**PLAN COMMISSION**

**July 24, 2014**

## **Plan Commission Report**

To: Village of Johnson Creek  
From: Michael A. Slavney, FAICP  
Date: 16 July 2014  
Re: Review of Keagen Properties, LLC Planned Development

Sheet Title  
**BUILDING ELEVATIONS**

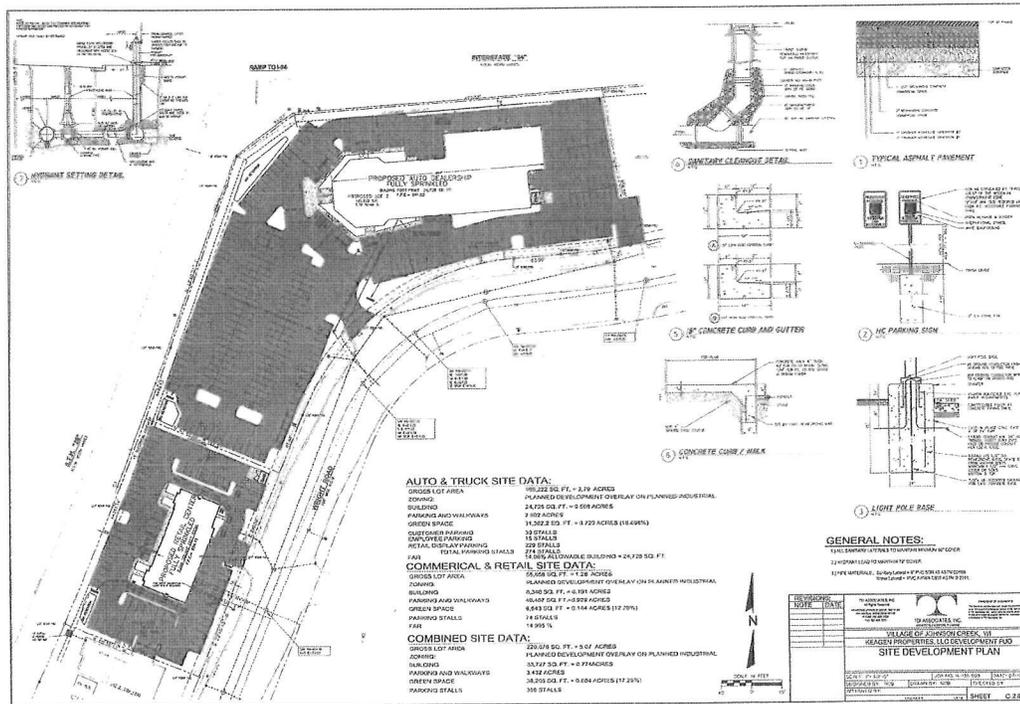
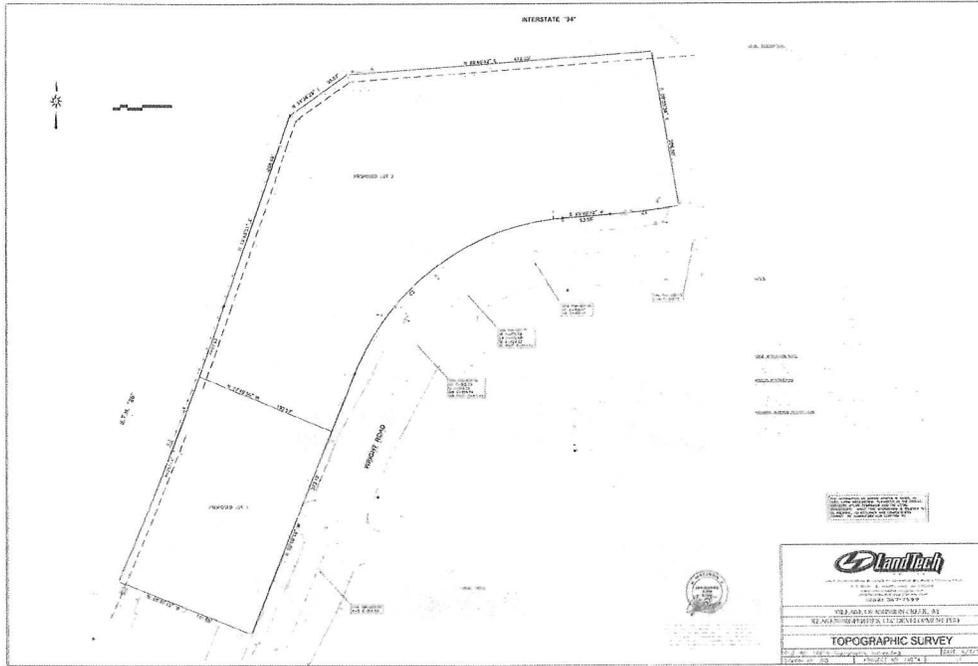
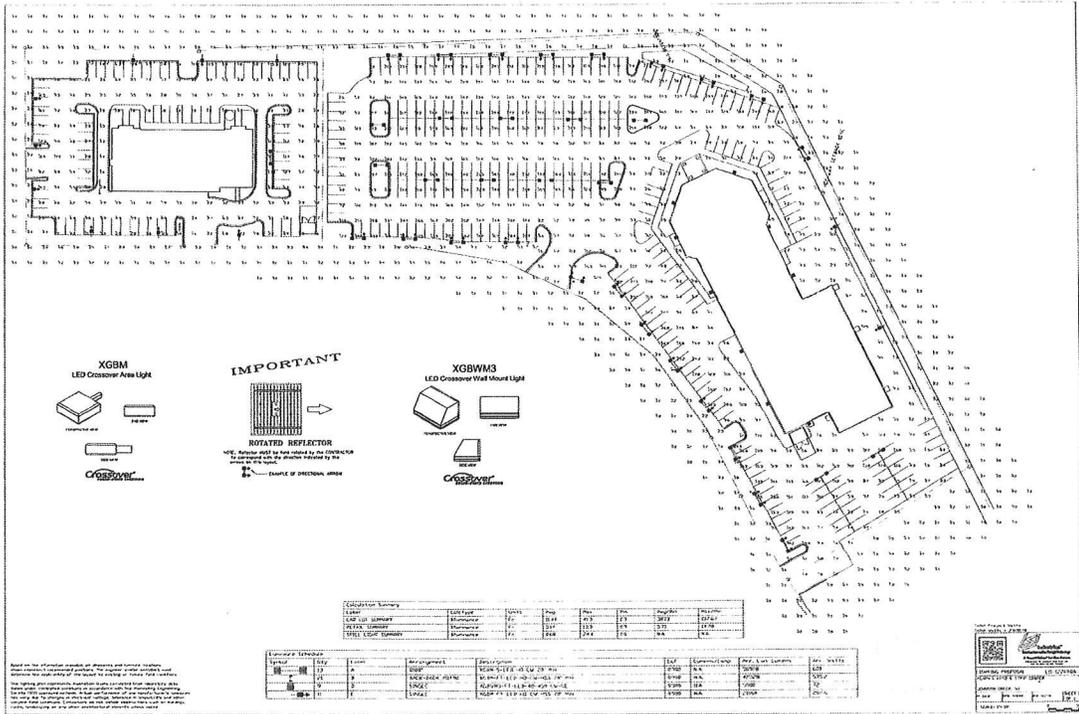
In response to Plan Commission concerns, the exterior of the car dealership building has undergone a significant upgrade. Exterior walls are now masonry and glass for the entire building, including the service center area. The vertical metal fascia on the overhang of the service center area has been replaced by horizontal metal, as an accent feature. This design will be echoed in the rolled standing seam metal roof over the main entry canopy. I think the building exterior has come a long way.

To: Village of Johnson Creek  
 From: Michael A. Slavney, FAICP, Village Planner  
 Date: 17 July 2014  
 Re: Site Plan Review Comments on Pernat Meats Additions on Grell Lane

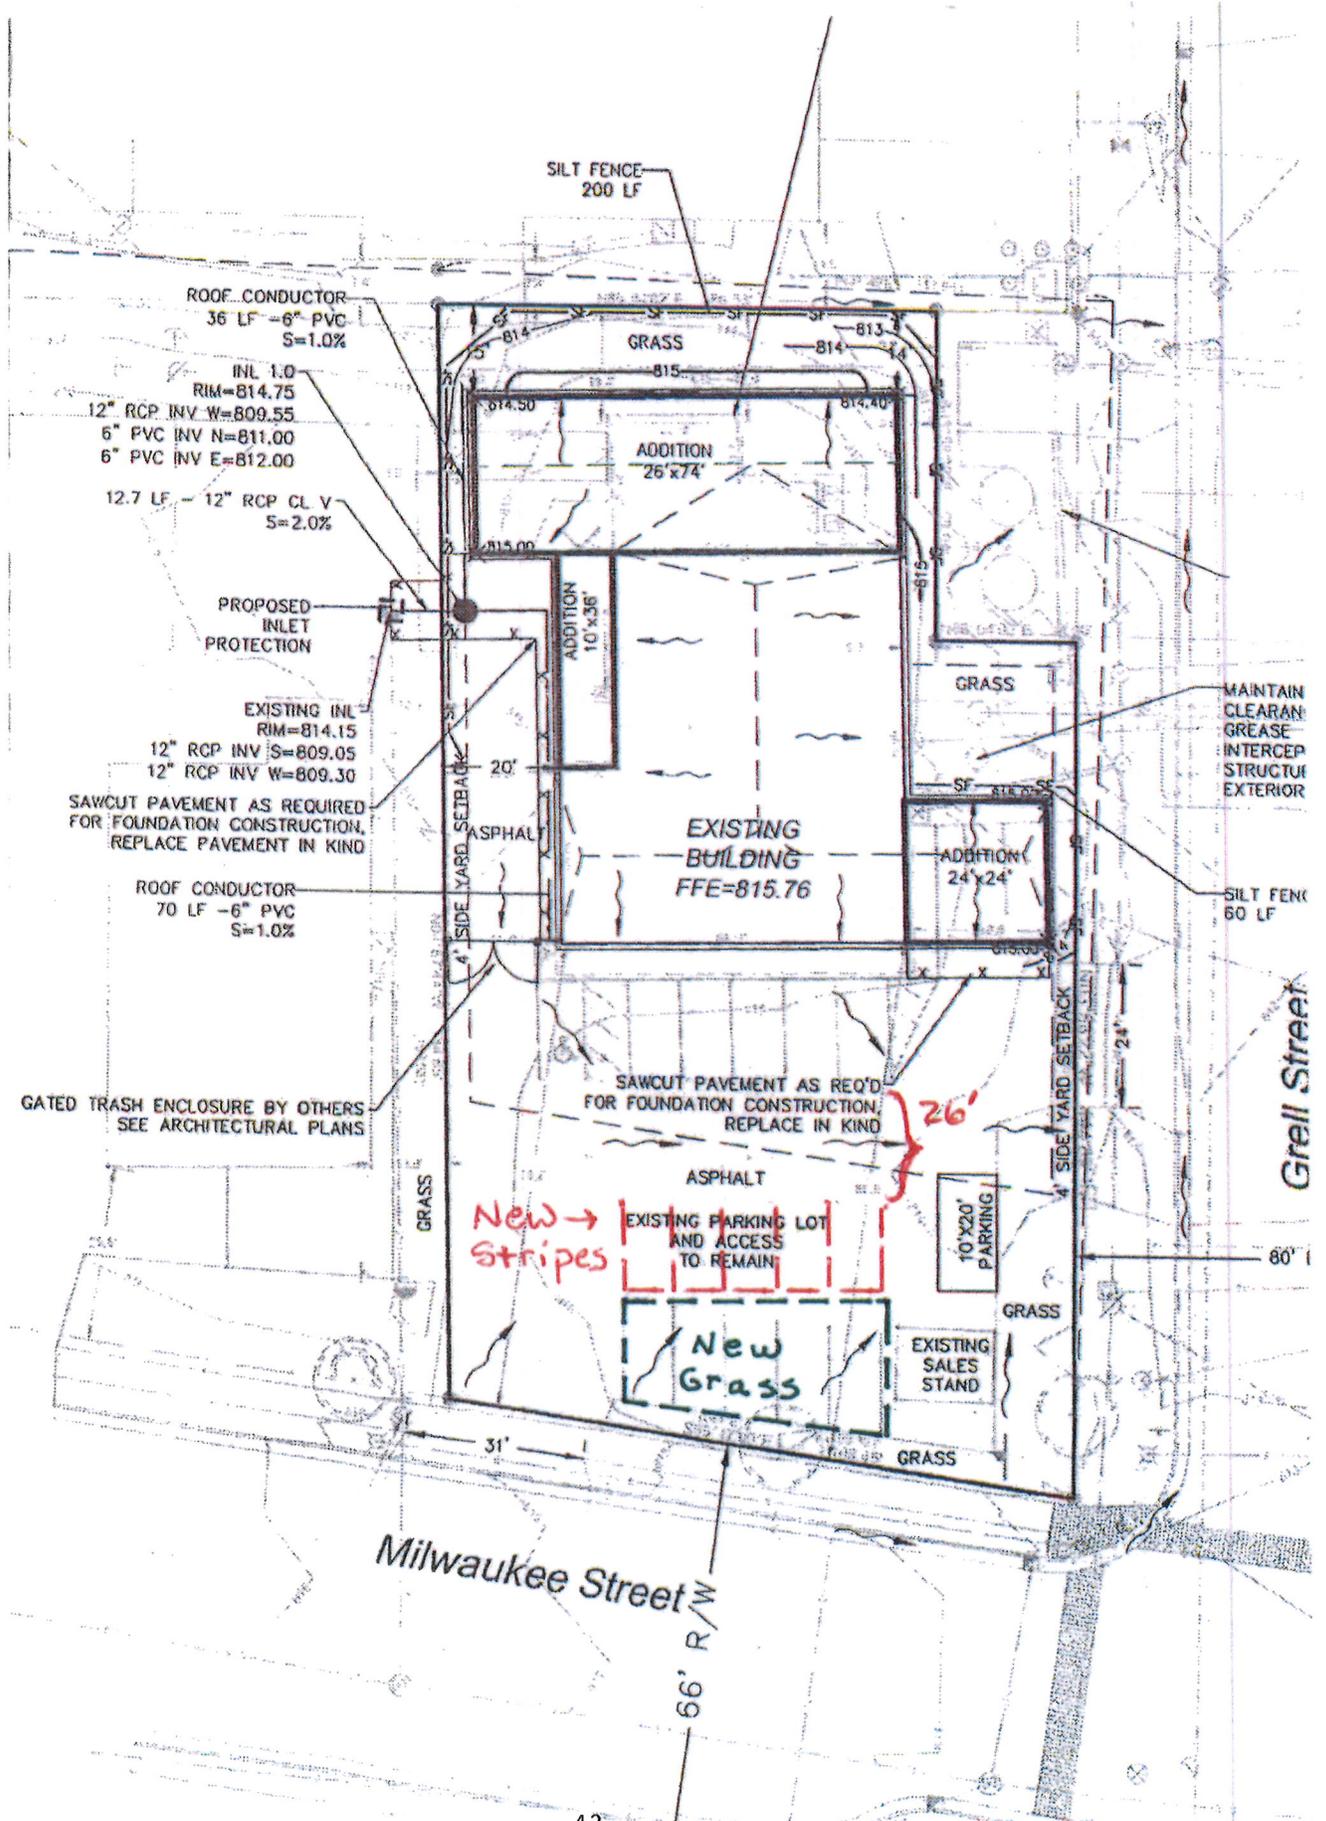
1. The building design and selection of materials are appropriate. Specific materials and colors are not specified on the building elevation drawings. Material samples should be shown at to the Plan Commission for approval by the Commission.
2. The design and materials of the trash enclosure doors should be specified. Generally, the Village has required cedar doors.
3. The proposed building additions of will further decrease the amount of green space on the site by 680 square feet. The current green space area percentage of 22%, is already a below the required minimum percentage of 25%. To mitigate the proposed increase in impervious surface area further above the maximum permitted percentage, I suggest a simple modification of the existing front parking area:

Specifically, the front parking area provides a center drive aisle that is about 40 feet wide – versus the 26 feet required by the Zoning Code. If the aisle was reduced to the standard 26 feet, 14 feet of green space could be added to the fifty foot wide green space area bordering Milwaukee Street at the south end of the parking lot – without a loss of parking spaces. The result would be a net increase in green space of 20 square feet over the current site plan, while still accommodating all of the proposed building additions.

4. Two large trees should be planted in this area to meet landscaping requirements.
